PLANNING NMA-CHANGE LIST		
ID	Proposed Changes to plans that are 'Non Material'	Reason for 'Amendment'
A	Changes to Common stair towards compliance for general access where a clear landing needs to be provided and to accommodate smoke control. Circulation area and internal doorway to stairs rearranged to adapt corridor aisle. Stairs, structurally stacked for construction leading towards the corridor or lobby next to the stair being provided with a smoke vent and a store area provision on ground level. Rearrangement in plan due to the above visible on the Northwest facade. Window openings, adapted to suit mentioned changes/rearrangement.	Compliance towards Building Regulations, Part-K-Protection from falling, collision and impact and Part-B-Fire safety
B	Changes to Communal lifts and stairs towards compliance for firefighting where a firefighting shaft is required as the building is over 18m and to accommodate smoke control and building services. Circulation area internal doorway to stairs and clear landing for lifts rearranged to adapt corridor aisle. Stairs, structurally stacked for construction leading towards a vertical smoke shaft that opens at roof level with rationalised comm

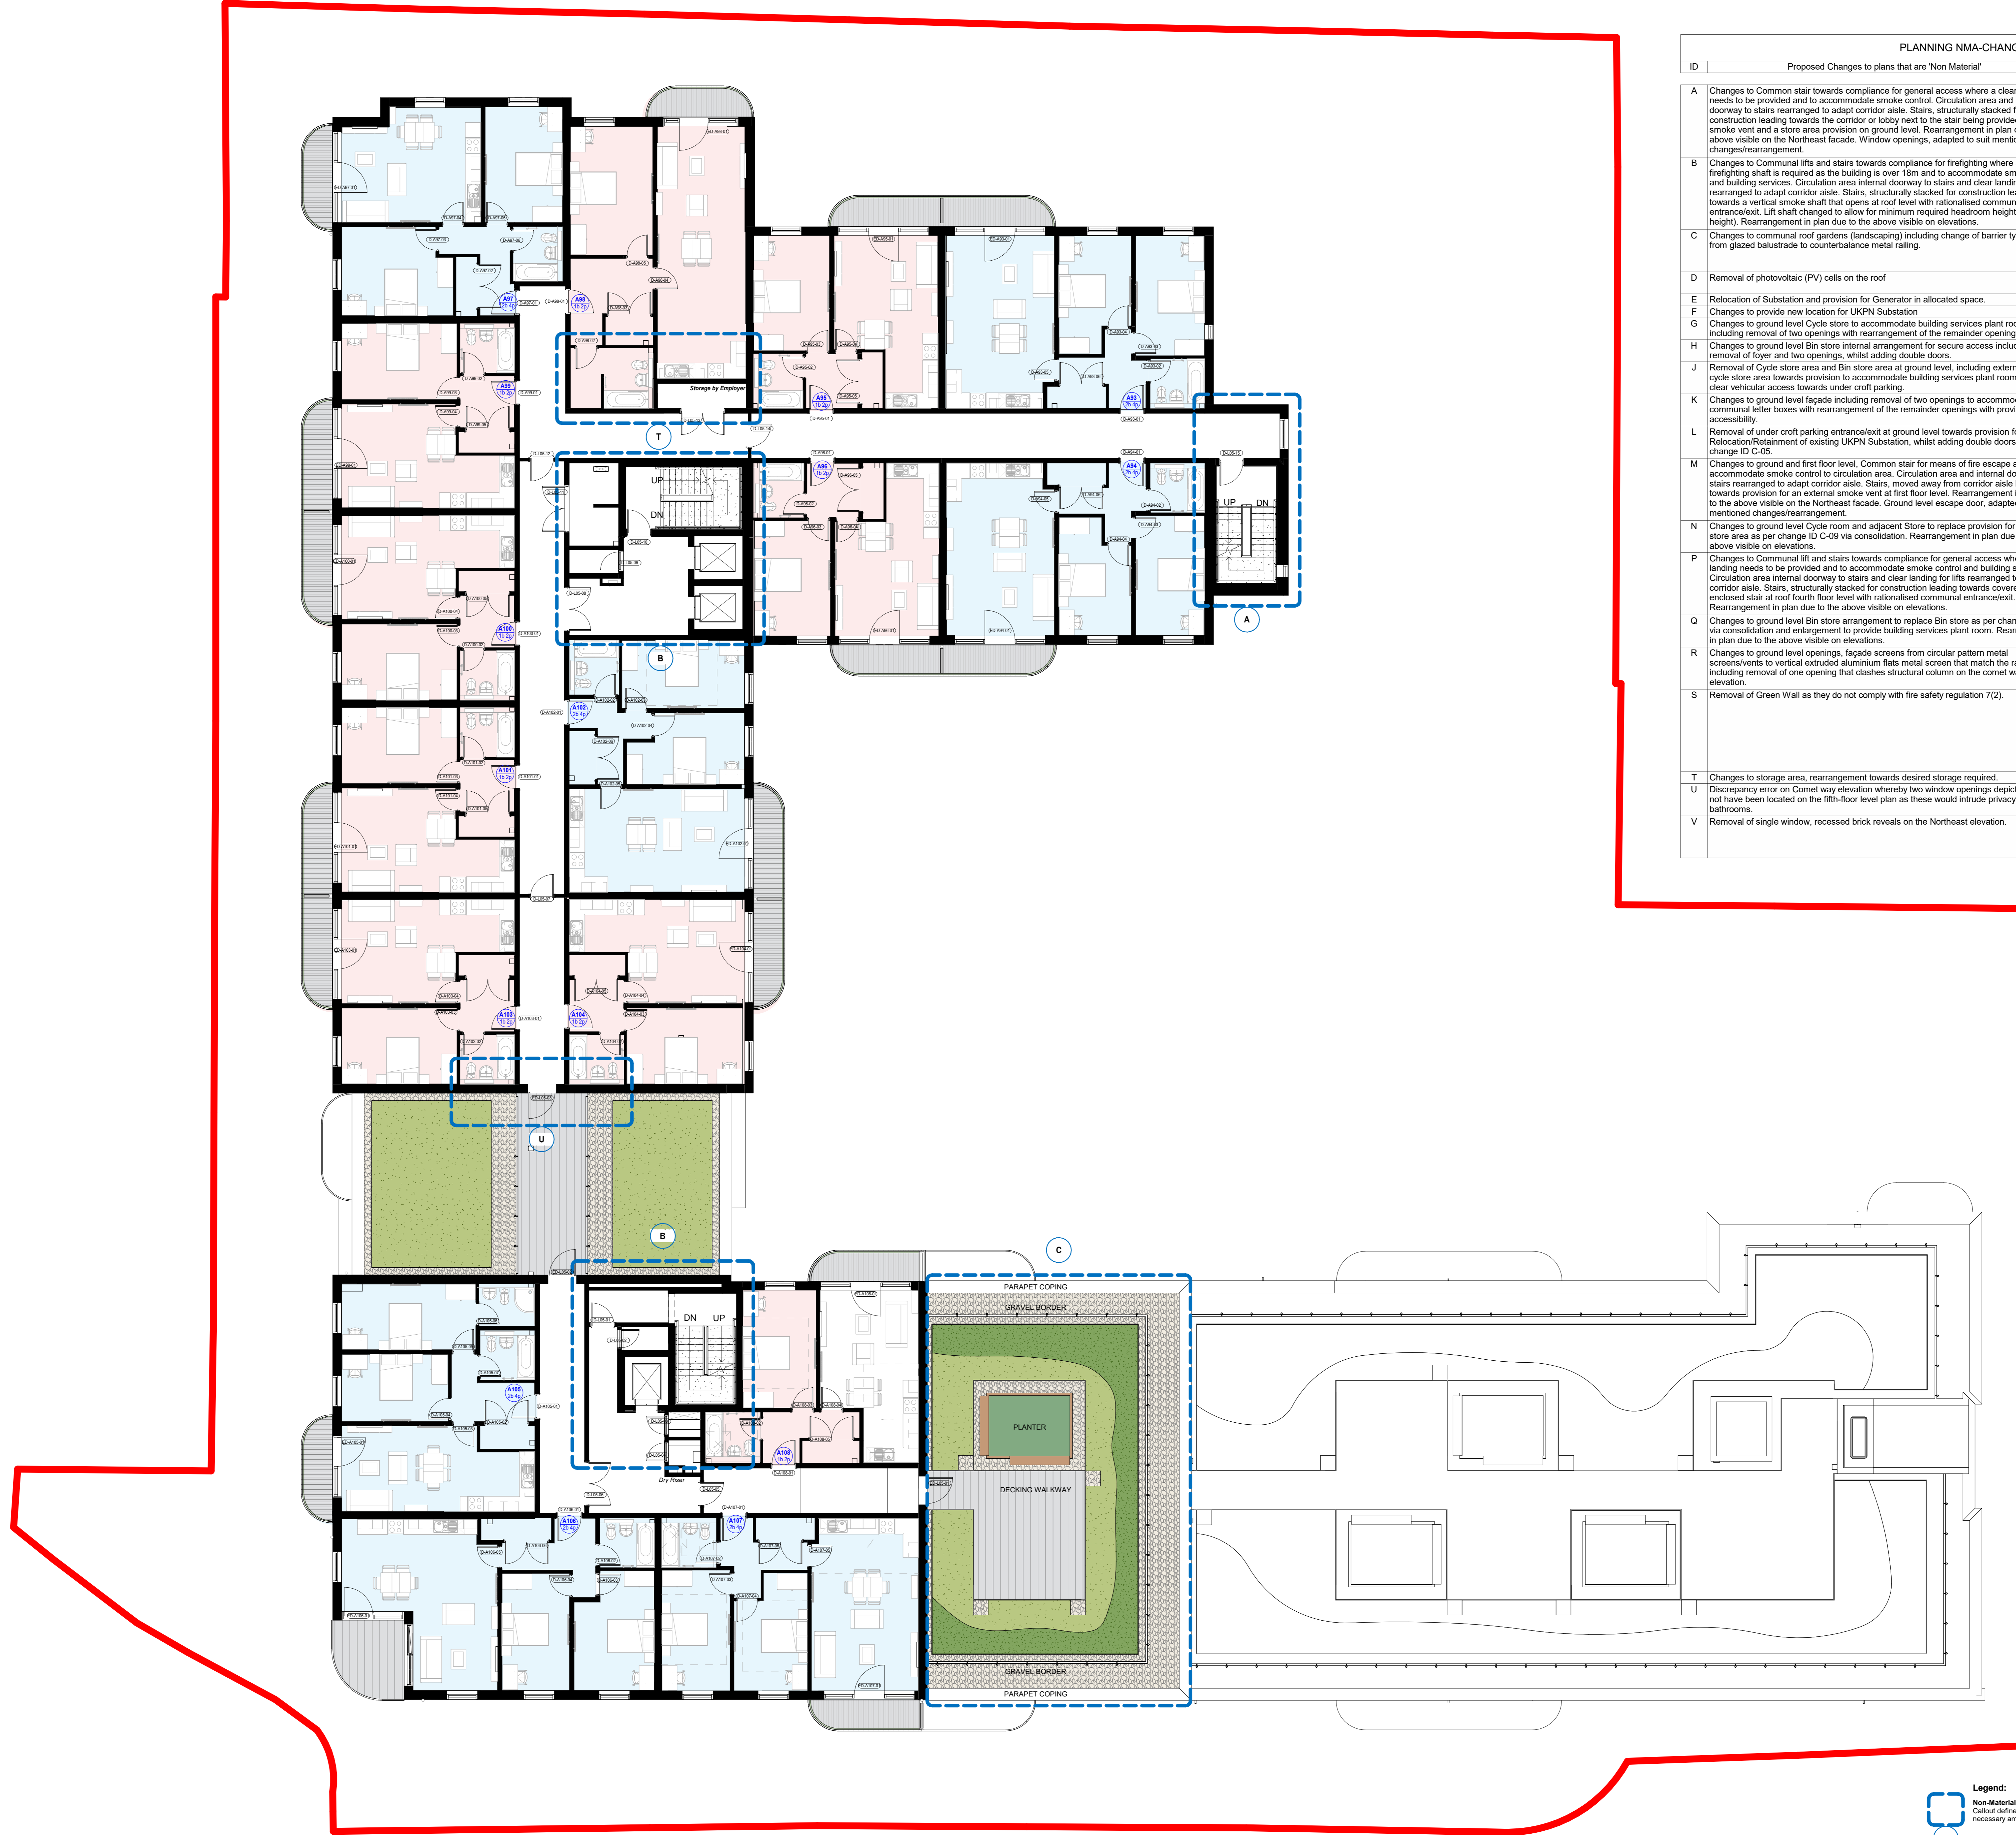
C	Changes to communal roof gardens (landscaping) including change of barrier type (railing) from glazed balustrade to counterbalance metal railing.	To contribute positively towards biodiversity via balance of soft and hard landscaping schemes including provisions for bird and bat boxes, whilst maintaining overall uniformity for railing type.
D	Removal of photovoltaic (PV) cells on the roof	PV was not required as Part L requirement was met using Exhaust Air Heat Pumps.
E	Relocation of Substation and provision for Generator in allocated space.	Provision for separate secluded area for generator
F	Changes to provide new location for UKPN Substation	Provision for future relocation for UKPN Substation
G	Changes to ground level Cycle store to accommodate building services plant rooms including removal of two openings with rearrangement of the remainder openings.	Provision towards Building Services, Secondary LV switch room and Corms room.

H	Changes to ground level Bin store internal arrangement for secure access including removal of foyer and two openings, whilst adding double doors.	Provision towards secure access for Bin store
J	Removal of Cycle store area and Bin store area at ground level, including external door in cycle store area towards provision to accommodate building services plant room including clear vehicular access towards undercroft parking.	Provision towards Building Services, Primary LV switch room and vehicular access towards undercroft parking.
K	Changes to ground level facade including removal of two openings to accommodate communal letter boxes with rearrangement of the remainder openings with provision for accessibility.	Provision towards communal letter boxes
L	Removal of undercroft parking entrance/exit at ground level towards provision for Relocation/Retainment of existing UKPN Substation, whilst adding double doors as per change ID C-05.	Provision towards single point of entry/exit for undercroft parking and towards relocation/retainment of existing UKPN Substation mentioned in change ID-E.

M	Changes to ground and first floor level, Common stair for means of fire escape and to accommodate smoke control to circulation area. Circulation area and internal doorway to stairs rearranged to adapt corridor aisle. Stairs, moved away from corridor aisle leading towards provision for an external smoke vent at first floor level. Rearrangement in plan due to the above visible on the Northeast facade. Ground level escape door, adapted to suit mentioned changes/rearrangement.	Compliance towards Building Regulations, Part-B-Fire safety.
N	Changes to ground level Cycle room and adjacent Store to replace provision for Cycle store area as per change ID C-09 via consolidation. Rearrangement in plan due to the above visible on elevations.	Provision towards replacement of removed cycle store mentioned in change ID-J.
P	Changes to Communal lift and stairs towards compliance for general access where a clear landing needs to be provided and to accommodate smoke control and building services. Circulation area internal doorway to stairs and clear landing for lifts rearranged to adapt corridor aisle. Stairs, structurally stacked for construction leading towards covered and enclosed stair at roof fourth floor level with rationalised communal entrance/exit. Rearrangement in plan due to the above visible on elevations.	Compliance towards Building Regulations, Part-K-Protection from falling, collision and impact, Part-B-Fire safety and Provision for stair enclosed/walkway that is directly covered.

Q	Changes to ground level Bin store arrangement to replace Bin store as per change ID C-09 via consolidation and enlargement to provide building services plant room. Rearrangement in plan due to the above visible on elevations.	Provision towards replacement of removed Bin store mentioned in change ID-J and provision for BCW Tank room.
R	Changes to ground level openings, facade screens from circular pattern metal screens/vents to vertical extruded aluminium flats metal screen that match the railing type, including removal of one opening that clashes structural column on the comet way elevation.	To maintaining overall architectural uniformity and structural framing.
S	Removal of Green Wall as they do not comply with fire safety regulation 7(2).	Regulation 7(2), requires all residential blocks with top storey heights over 18m to have all materials which become part of an external wall or specified attachment (e.g., balconies) to achieve class A2-s1, d0 or class A1, except for materials which are exempt as per regulation 7(3). Additionally, membranes used as part of external wall construction above ground should achieve a minimum of class B-s1, d0.

T	Changes to storage area, rearrangement towards desired storage required.	Provision towards desired storage required.
U	Discrepancy error on Comet way elevation whereby two window openings depicted would not have been located on the fifth-floor level plan as these would intrude privacy for the bedrooms.	Discrepancy error
V	Removal of single window, recessed brick reveals on the Northeast elevation.	The recessed brick reveals is between two windows mostly on all elevations, whilst single windows mostly do not have such a detail. To maintain architectural uniformity, detail removed.
